ENGAGEMENT

KEY CHANGES IN RESPONSE TO ENGAGEMENT WITH COMMUNITY/PLANNERS:

Figure 65

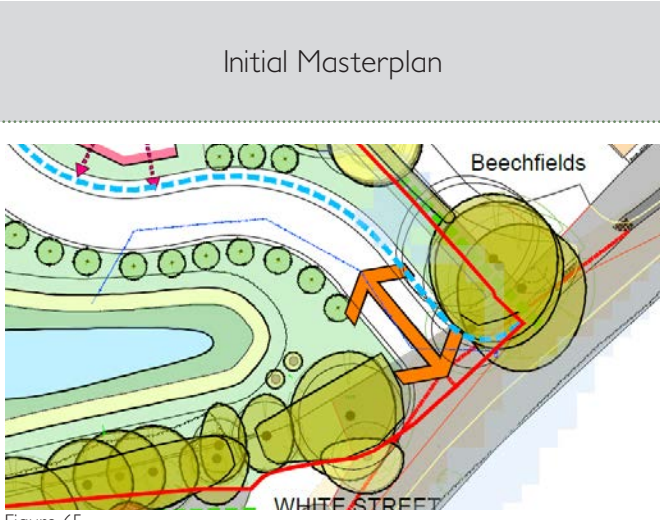
The access has the potential to impact on important trees and hedgerows that contribute to the character of White Street, including within Group G15, which are located within the West Lavington Conservation Area.

1. Alteration to access to avoid impact to Beech Trees on access

The access to the site has been adjusted, shifted further west to take into account feedback from the Tree Officer and the findings of the low invasive air spading investigations, avoiding harm to the prominent off-site tree group of three beech trees.

Figure 69

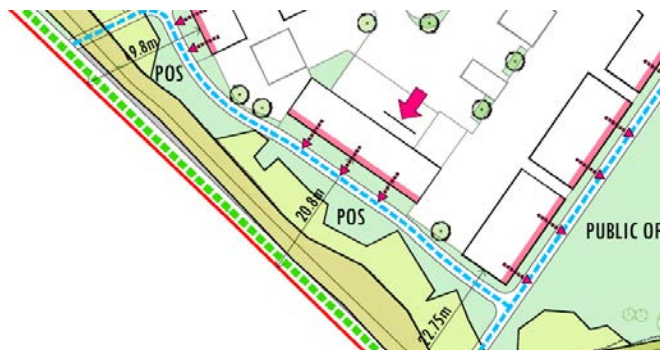
3. Additional provision of a swale along the western boundary

Pre-application comments noted a significant surface water flow path through the site. The inclusion of swales along the western boundary offers a more robust solution for runoff from the upstream catchment, offering further protection to future properties.
